World Forum for Harmonization of Vehicle Regulations

180th session

Proposal for the 04 series of amendments to UN Regulation No. 26 (External projections of passenger cars)

04 series of amendments to UN Regulation No 26 (External projections of passenger cars)

Figure 0: Example of parts distribution

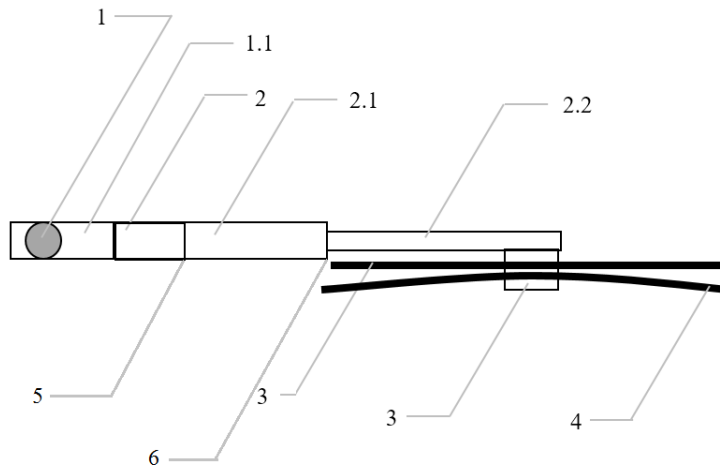
Paragraphs 6.4. to 6.4.2., amend to read:

- "6.4. Windscreen wipers
- 6.4.1. The windscreen wiper fittings shall be such that the wiper shaft (number 1 in Figure 0) is furnished with a protective casing (number 1.1 in Figure 0) which has a radius of curvature meeting the requirements of paragraph 5.4. above and an end surface area of not less than 150 mm². The holder (head and main part, i.e. numbers 2, 2.1 in Figure 0) are designed with a radius of curvature meeting the requirements of paragraph 5.4. above. In the case of rounded covers, these shall have a minimum projected area of 150 mm² when measured not more than 6.5 mm from the point projecting furthest. These requirements shall also be met by rear window wipers and headlamp wipers.

- 6.4.2. Paragraph 5.4. shall not apply to the wiper blades (number 4 in Figure 0), supporting members (number 3 in Figure 0) if present, to second holder (number 2.2 in Figure 0) if present, to the functional hinge between the holder head and the holder (number 5 in Figure 0) if present, or to the junction between the main and the second holder (number 6 in Figure 0) if present. However, these units shall be so made as to have no sharp angles or pointed or cutting parts.

Model A

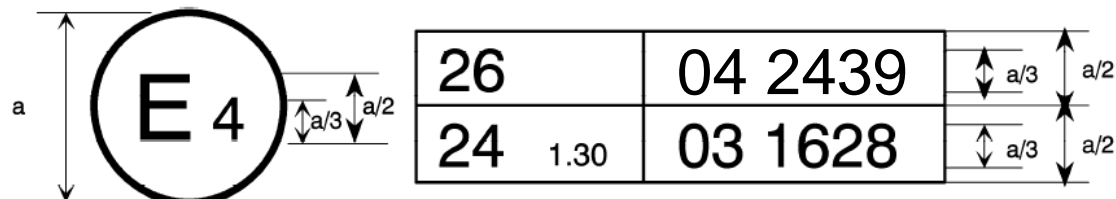
Annex 2, amend to read

The above approval mark affixed to a vehicle shows that the vehicle type concerned has been approved in the Netherlands (E 4) pursuant to UN Regulation No. 26 and under approval number 032439. The first two digits of the approval number indicate that UN Regulation No. 26 already included the 04 series of amendments when the approval was granted.
